PROJECT: Addison Airport
 Addison Airport US Customs and Border Protection Facility
 JC Commercial – Change Order No. 3

Change Order Number: 3

Project Name: Addison Airport US Customs and Border Protection Facility

Re: Narrative for Proposal #24-24a – Wall Adjustments (Drywall)(Revised)
Project No: 417151

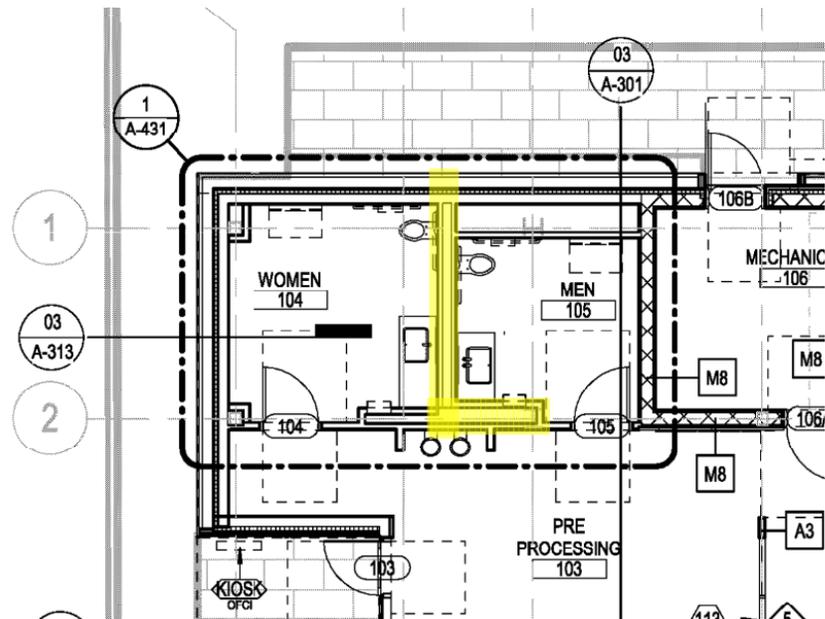
The first location in question was the plan east wall of Processing 109 where we had a sink being installed on the inside of an exterior CMU block wall. All CMU walls were noted to have a 7/8" hat channel with a 5/8" layer of drywall installed on them as a typical note from our partition types sheet. This drywall cladding layer does not allow enough thickness to conceal the required plumbing pipes within it to plumb the sink. We allowed the GC to change this interior cladding layer to an F3 furring wall which has a 3-5/8" stud attached to the block wall with a layer of 5/8" thick drywall cladding. This modification provides the required space to conceal the plumbing in the wall. Hat channels had already been installed when the question came up, so some re-work was required based on this change. See below for reference:

The next location we had an issue was at the wet wall plumbing chase between Women 104 and Men 105 single use restrooms on Level 01. The plumbing chase depth provided in the documents was too narrow to accommodate the back to back toilet carriers and any plumbing crossovers. We allowed the GC to expand the width of this chase and modify its extents slightly to make everything fit. We double checked all required ADA clearances prior to allowing the shift in chase size just to be safe. Some framing had already been completed in this area when the issue was noted so a minor amount of framing rework was required. See below for reference:

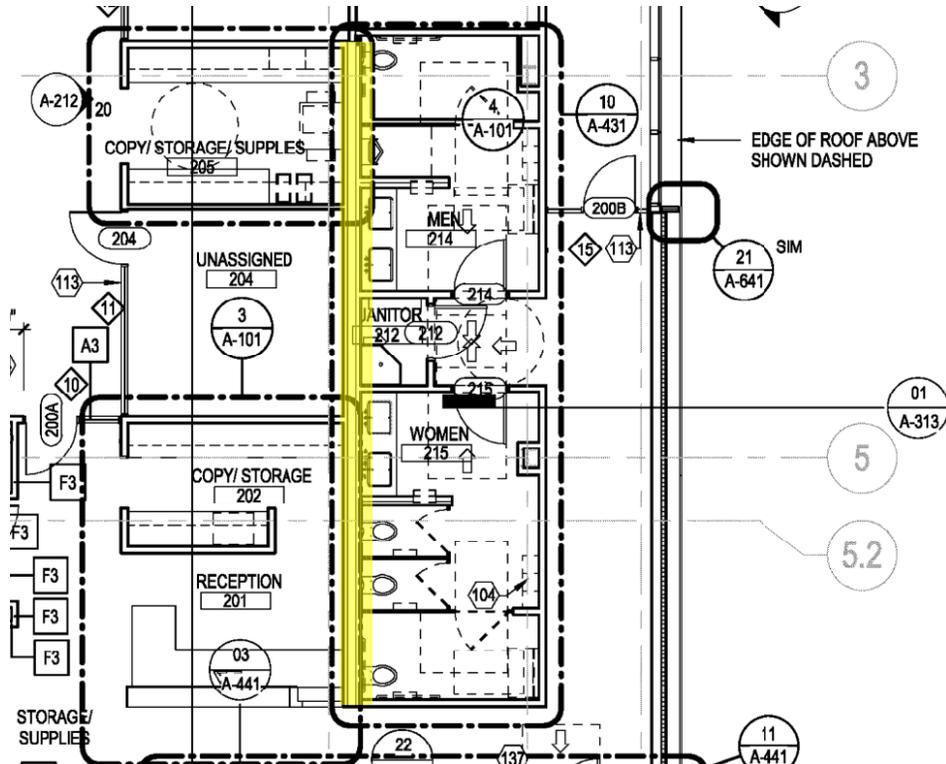
The third location where an issue was noted was the plumbing chase wall at both Men 214 and Women 215 gang restrooms on Level 02. The plumbing chase depth provided in the documents was too narrow to accommodate the toilet carriers and any plumbing crossovers that were needed. We allowed the GC to expand the width of this chase to make everything fit. We double checked all required clearances prior to allowing the shift in chase size to be safe. Some framing was already complete when the issue was noted so a minor amount of rework was required. See below for reference:

Subject: Chase Wall
Category: Architectural

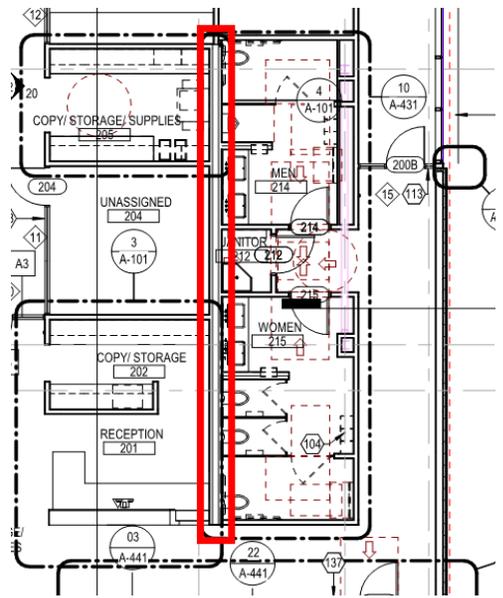
Please see markup below. The chase wall between rooms 214/215 and rooms 201/202/204/205 needs to have a minimum clearance of 14" (Required for the depth of the carriers) from inside drywall to inside drywall and the plans currently account for 10 3/8" of space. Please advise on how to proceed.

See attached mark-up for further direction - Shift the plan east wall of the plumbing chase to the east by 3 5/8" to allow for the required 14" of space required in the plumbing chase. Other shifts are noted to the toilet partitions related to this shift - GC to coordinate with the toilet partition installer as required.

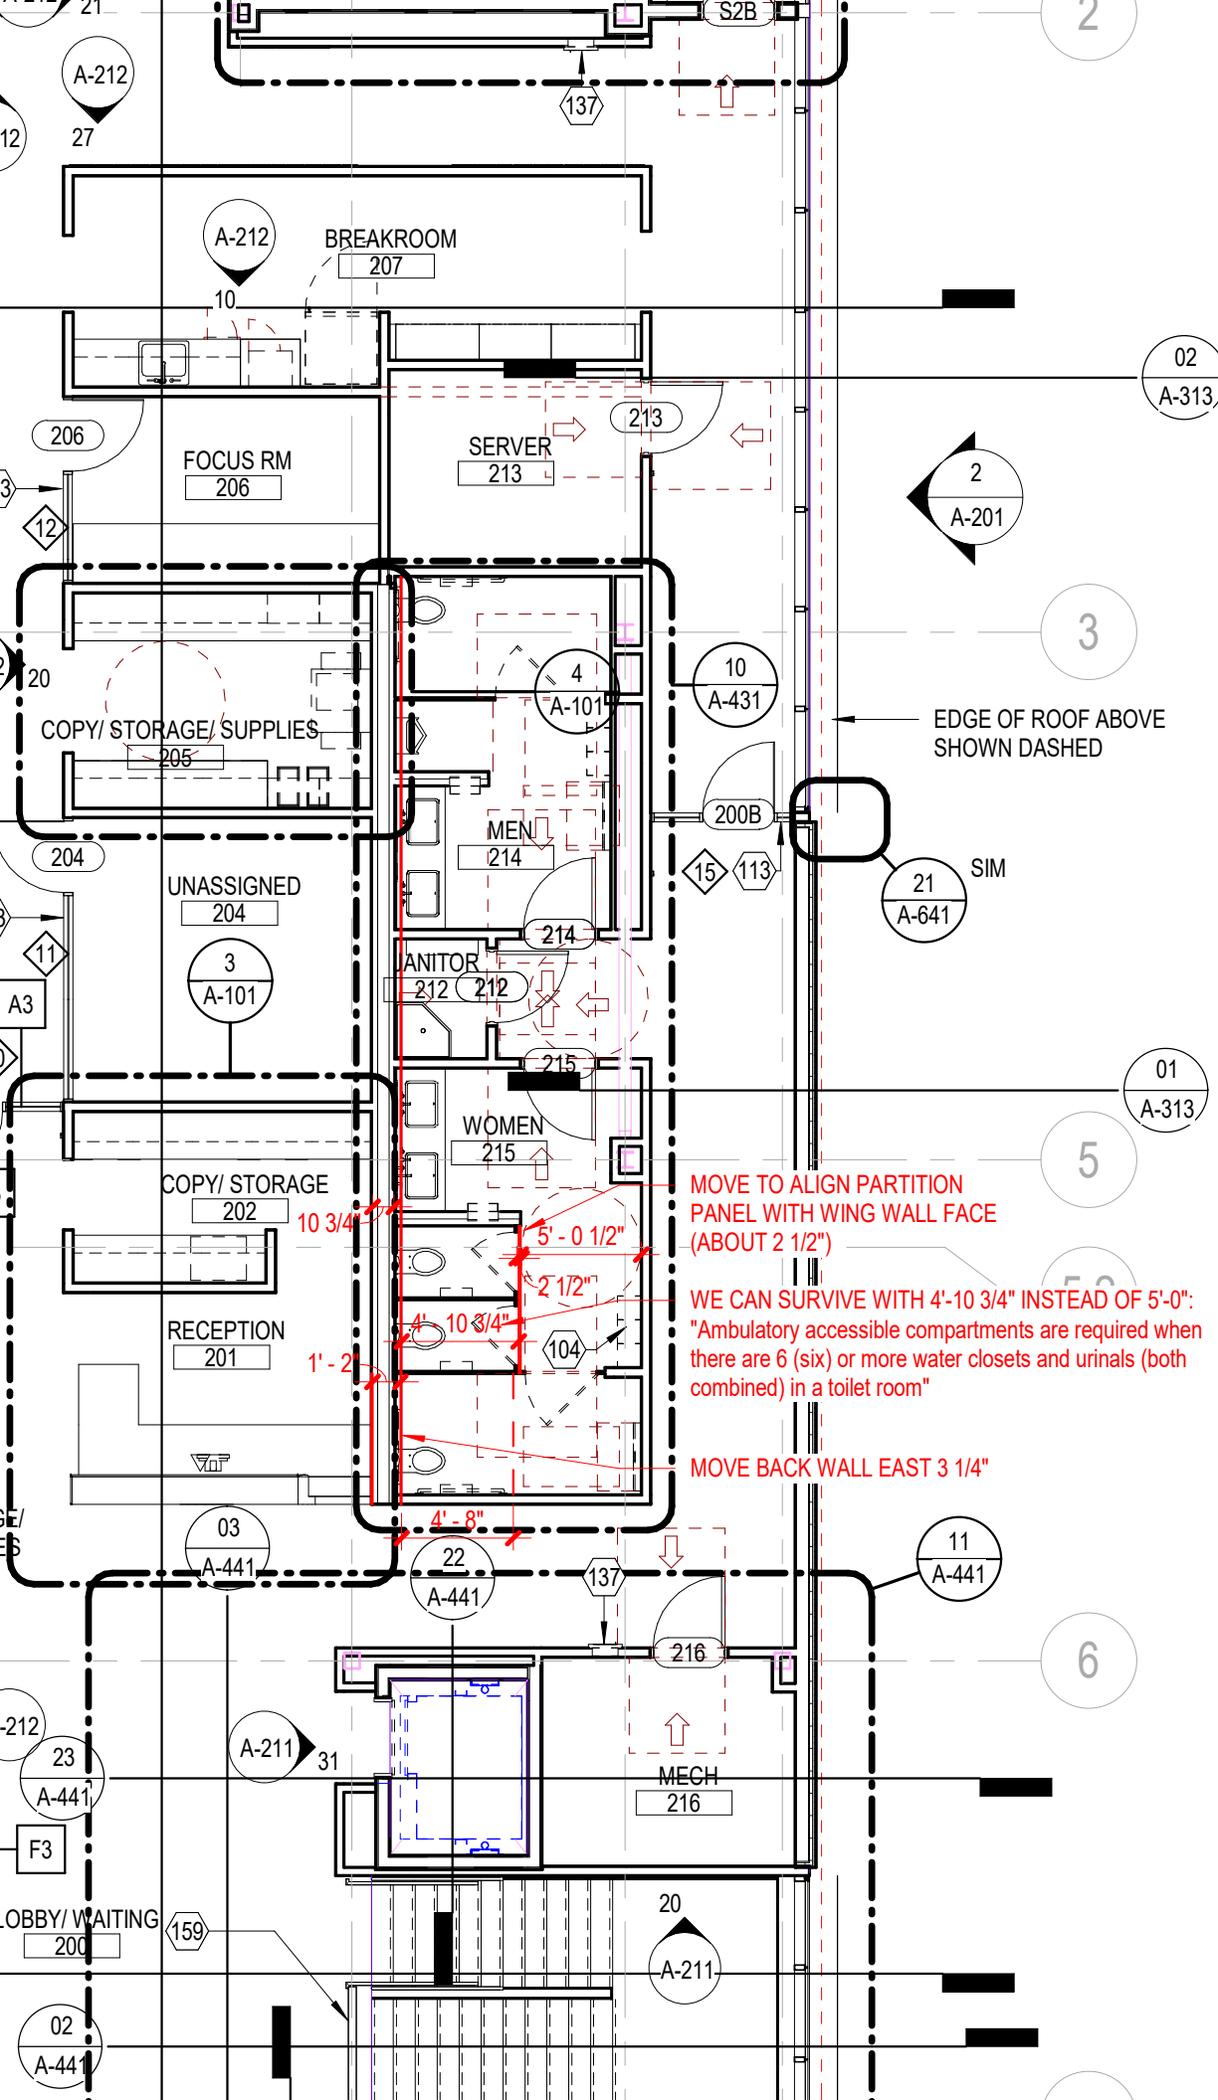
Question: Please see markup below. The chase wall between rooms 214/215 and rooms 201/202/204/205 needs to have a minimum clearance of 14" (Required for the depth of the carriers) from inside drywall to inside drywall and the plans currently account for 10 3/8" of space. Please advise on how to proceed.

Product Data Sheet: Topsoil

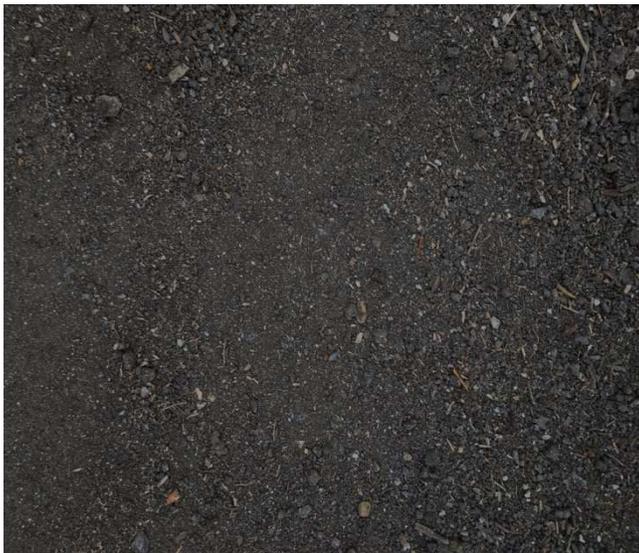
REVIEWED FOR USE AS FINE
GRADING IN SOD AREAS ONLY.
CONTRACTOR TO SUBMIT PHYSICAL
SAMPLE AND MOST RECENT TESTING
DATA FOR FINAL ACCEPTANCE.

PLANTING PLAN

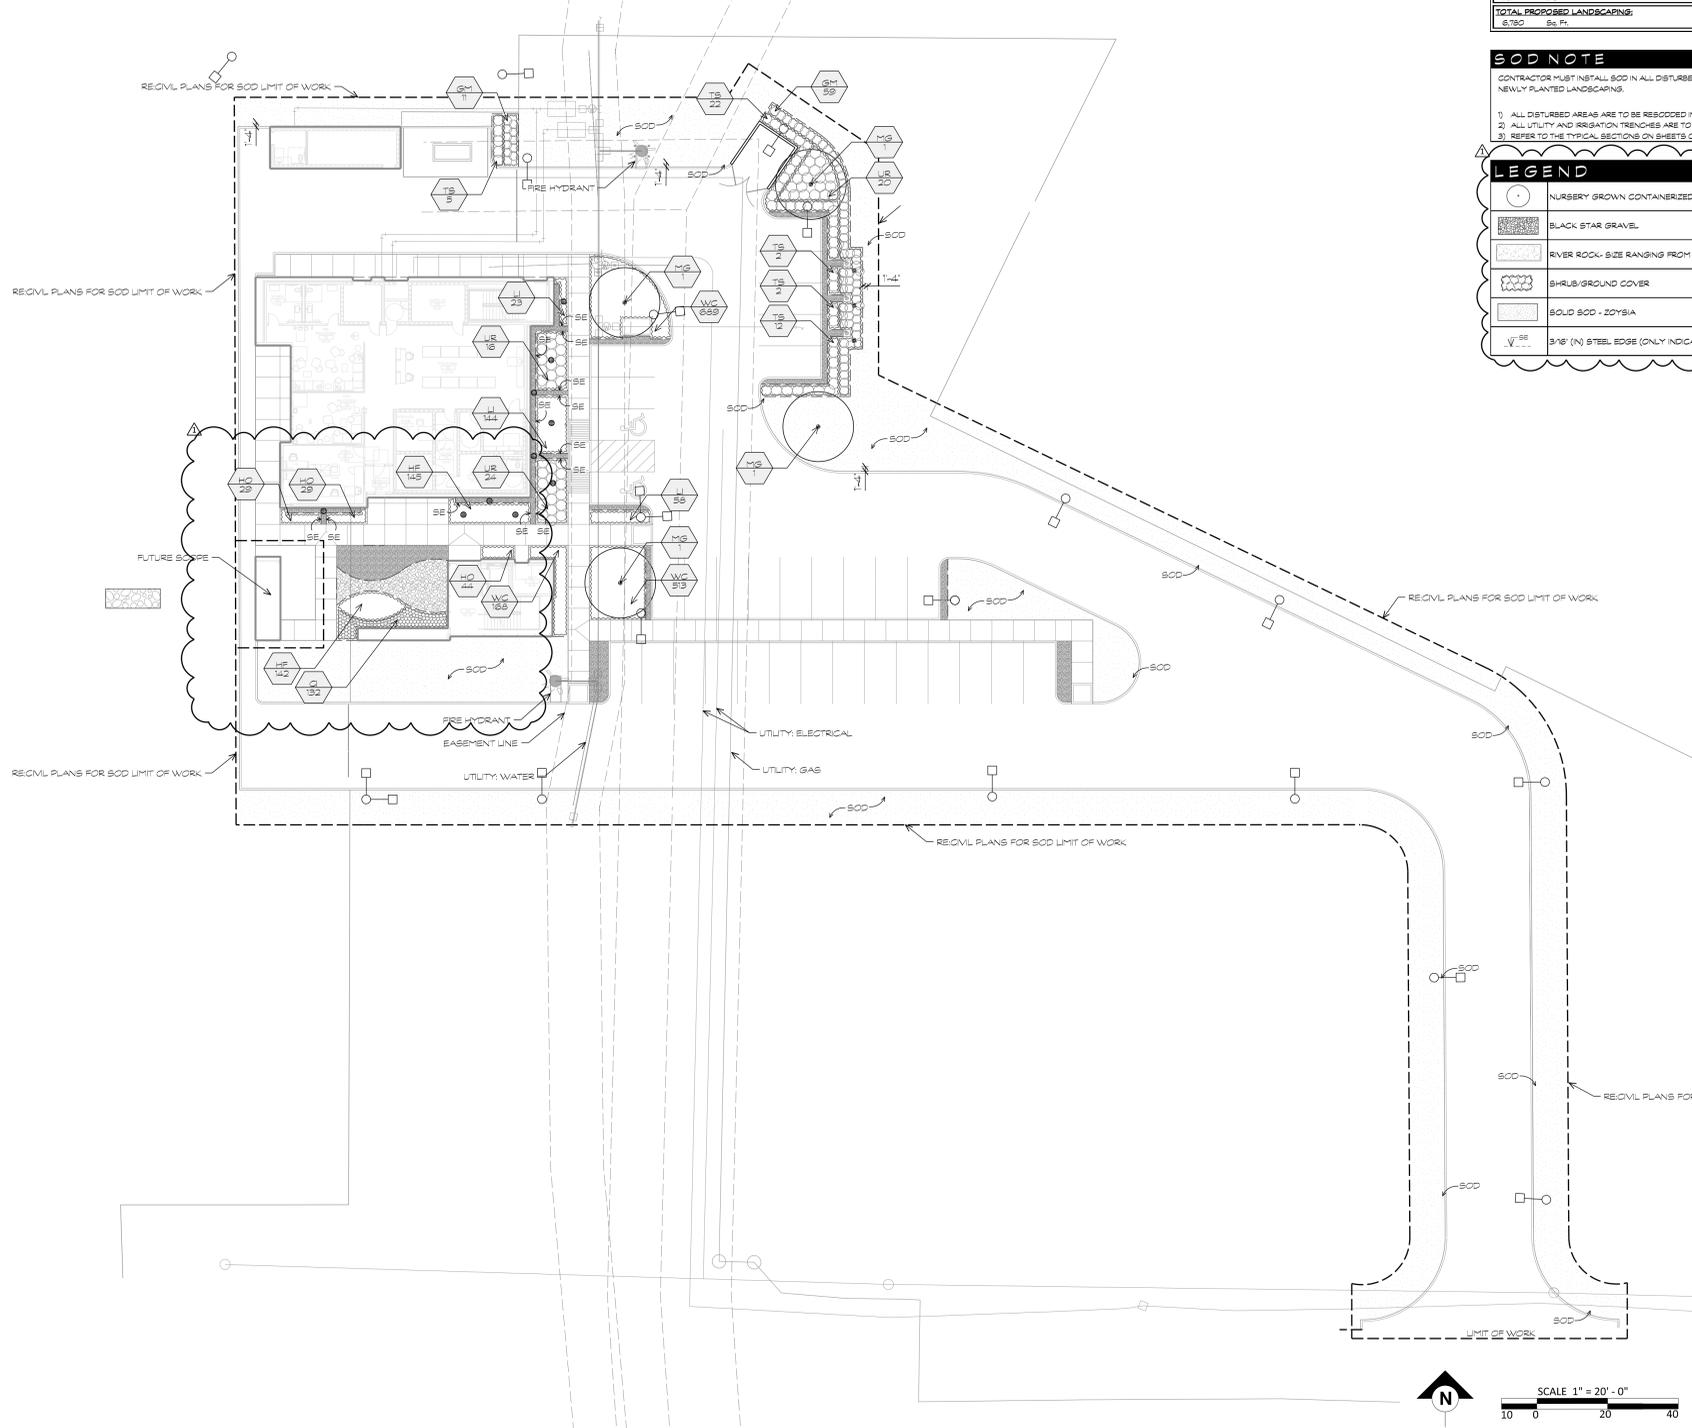
SEE ATTACHED UNOFFICIAL REVISION TO PLANTING PLAN (WILL BE ISSUED ONCE ASSIGNED A PR NUMBER BY PSP). CONTRACTOR TO REVISE SUBMITTAL TO INCLUDE NEW PLANT SELECTIONS AND RIVER ROCK FOR PLANTING AREA UNDER CANOPY. INCLUDE ALL REQUIRED SOIL TESTING DATA IN REVISION.

Exterior Elevations from sheet A-201 after the revisions (Current):

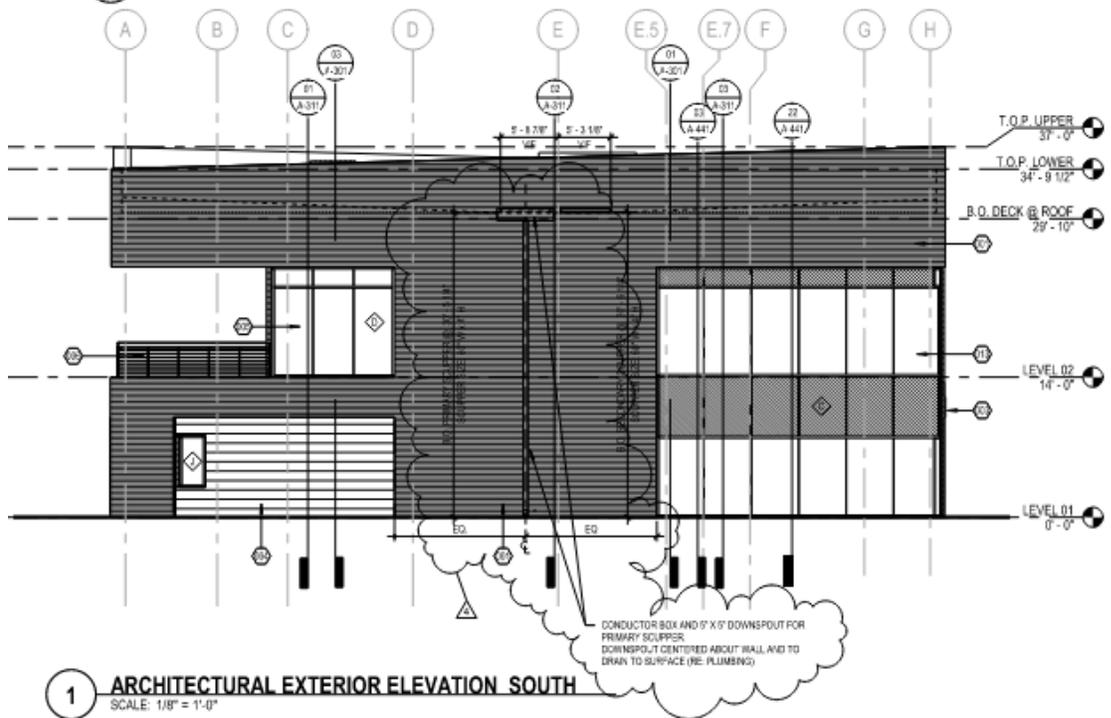
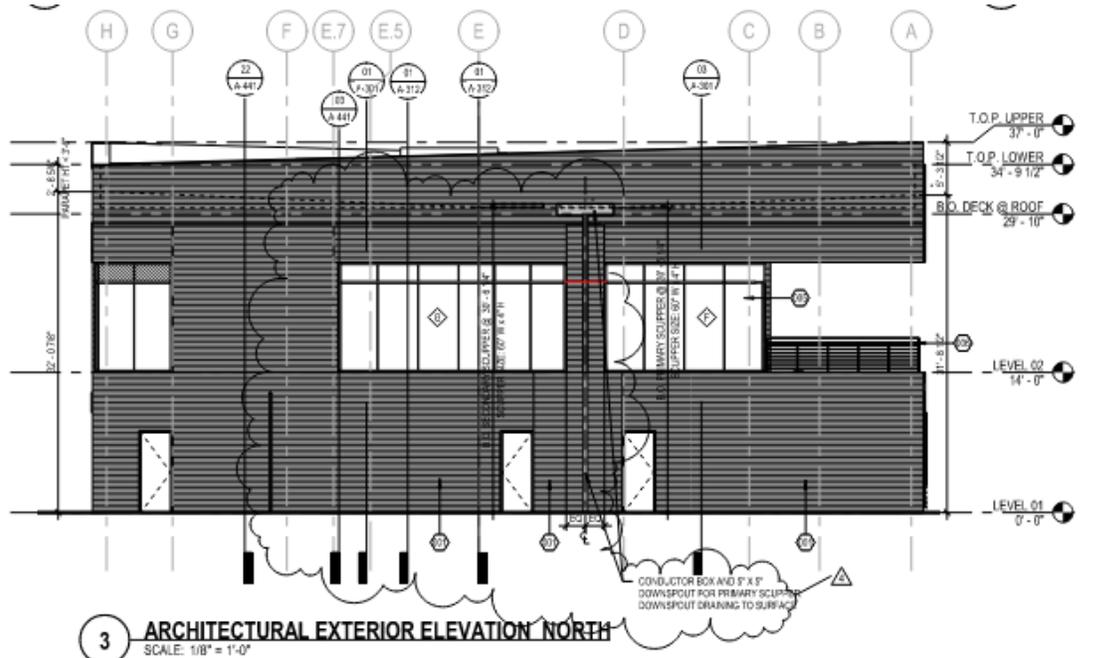
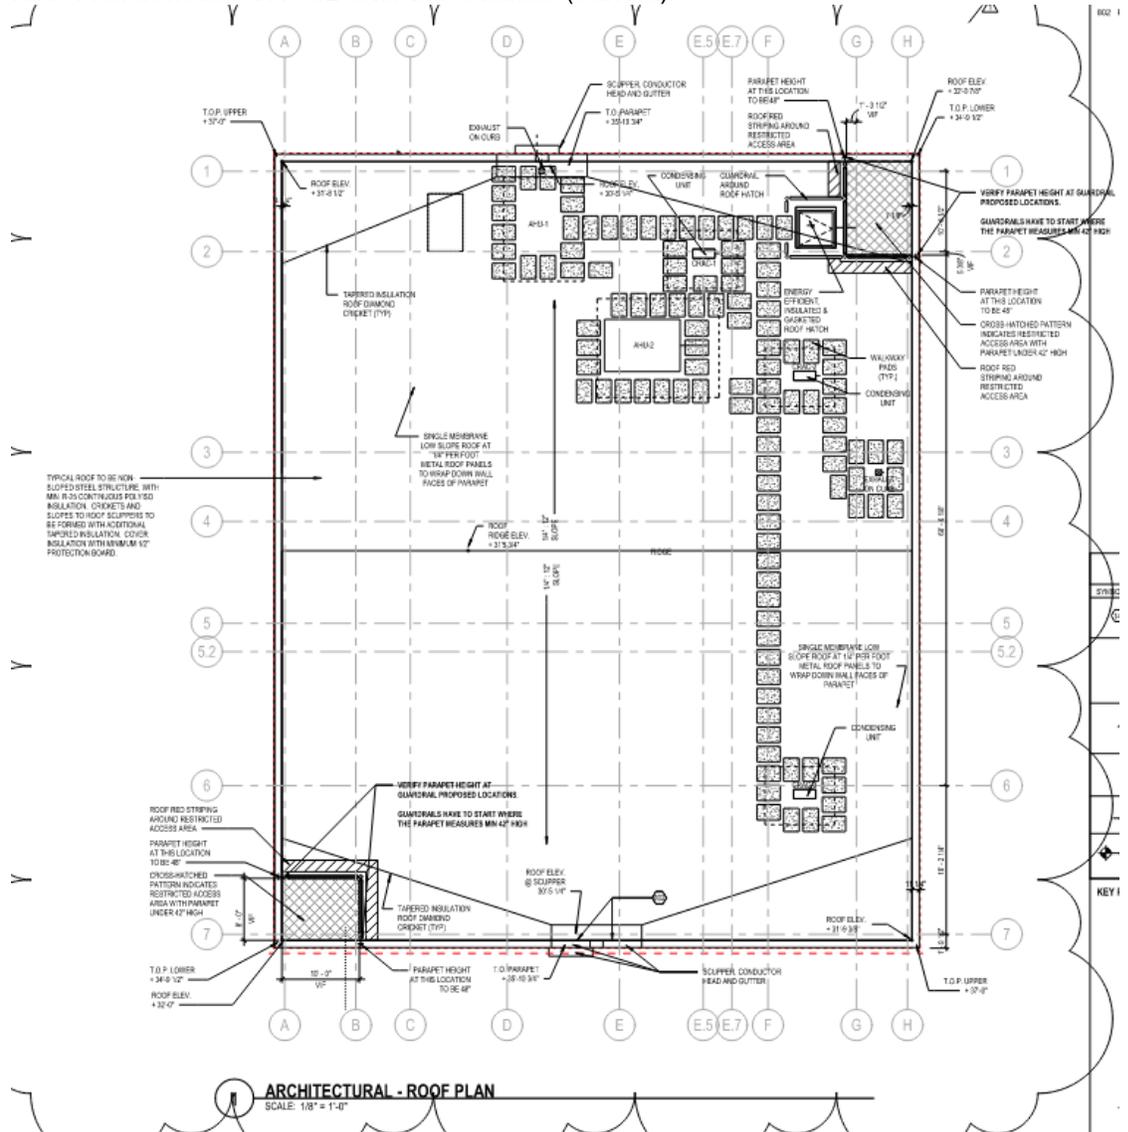
Proposal #28 was the result of comments from the Town of Addison Building Department during the final permit plan review process that began on October 24th, 2019. This package was resubmitted for a final review after the ASI 01 changes (issued on October 10th, 2019) had been updated throughout the documents. During the final round of review by the Town Building Department the reviewer asked a few specific questions about the calculations that were used to size the scuppers and downspouts that we had running down the north and south sides of the building to drain the roof. We worked with our engineers (Graver) to provide the calculations and other information that was requested. Based on feedback from the Town related to these calculations and what we had in the documents at the time, we changed the way we had these elements designed and added an overflow outlet adjacent to the original as a back-up. Unfortunately, the contractor had been proceeding with construction based on previously issued documents and partially constructed these scupper and downspout elements along with the openings in the parapet wall at the roof. When the review was completed and the comments were incorporated into the documents and issued out in the IFC package on April 6th, 2020 to the GC, there was re-work required to make what was built match the new requirements.

The changes the GC is asking for are reasonable based on where they were when the revisions were provided to them. If this work is not completed quickly, it will cost more to complete later since certain pieces of equipment are required to do this work and that equipment is only on-site until other ongoing work is completed. If the proposal is not approved prior to that equipment leaving the site, additional costs will be incurred to bring it back to the site to complete this work.
